FACSIMILE/ MAIL TRANSMISSION

Date: January 9, 2012 **File:** 07-2-256

RE: **REVISION OF BRIDGE AND ACCESS POINT ELEVATIONS**
PROPOSED SUBDIVISION
3707 DOLLARTON HWY - NORTH VANCOUVER, BC

| NO. | REVISION | DATE | APPROVED | CLIENT | TITLE | SCALE | FIG. NO. |
|-----|----------|------|----------|---|---|-------------|----------------|
| | | | | NICK EBRAHIM | Topography Proposed Bridge Sections and Plan | NTS | B-1 |

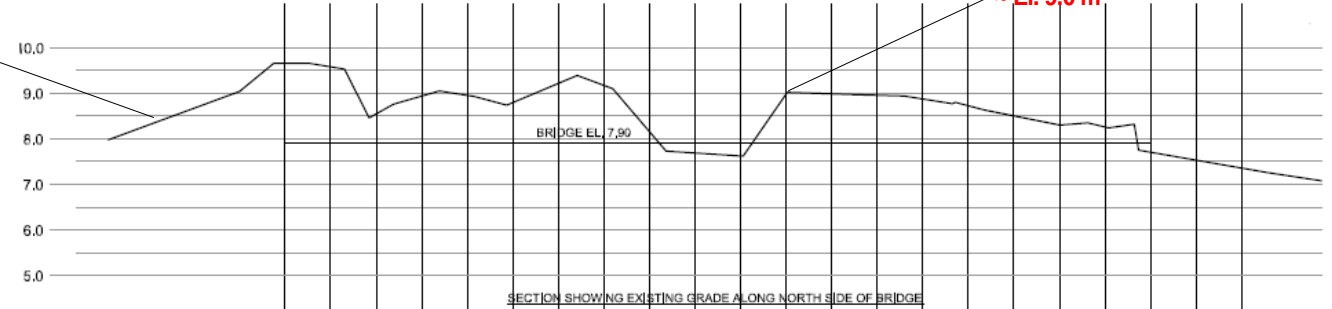
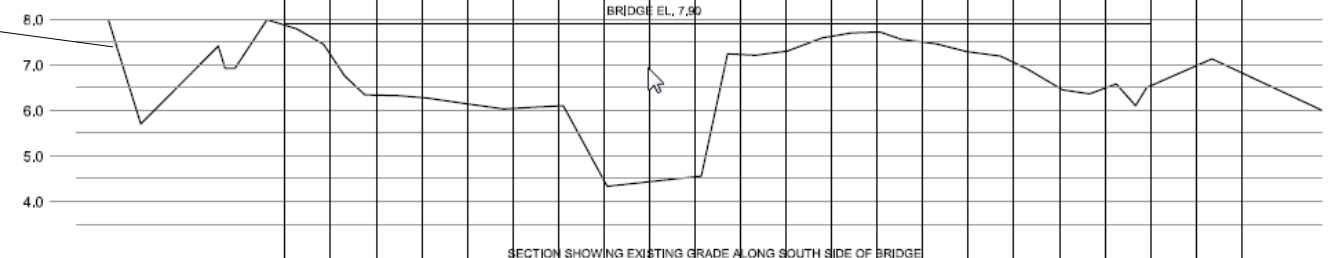
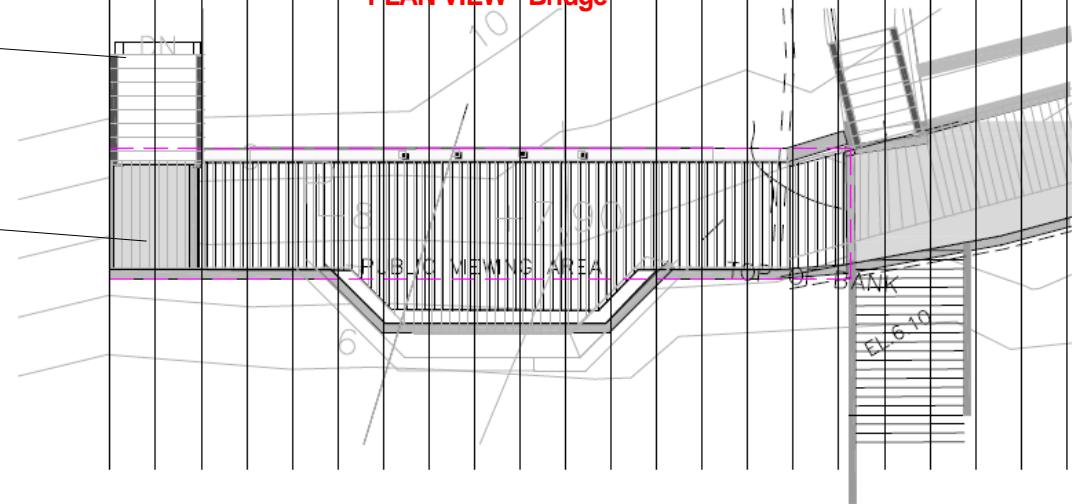
Topographic profiles in line with the north and south extremities of the bridge deck (refer to Figure B-1, attached) show the primary gully through which flow occurs.

The north extremity of the bridge will govern the potential exposure of the bridge. As shown in the Figure, flooding above elevation 9.0 m should result in channel waters flowing over the crest of the gully. The capacity of the channel, therein should increase significantly (during the flood event).

The currently proposed bridge deck elevation is 7.9 m. DNA has indicated that the deck supports would extend up to 0.5 m below the deck surface. This would result in deck supports at an elevation of about 7.4 m.

The current concept consists of an approximate 17 m span between the east and west pedestrian access points to the bridge deck. Currently, the east and west access points consist of stairs extending down to a west-side landing and the east-side waterfront walkway.

At this point, we envision that a bridge deck surface elevation of 9.7 m would significantly decrease the bridge's exposure to high water levels in the channel.

As discussed with Bill Harrison, the east and west access points would also need to be revised to account for the 1.8 m increase in elevation of the bridge deck. At this point, it appears that the proposed increase in deck elevation would result in less grade change for pedestrians access from upslope areas; a stairway would be required for pedestrians from the waterfront walkway.
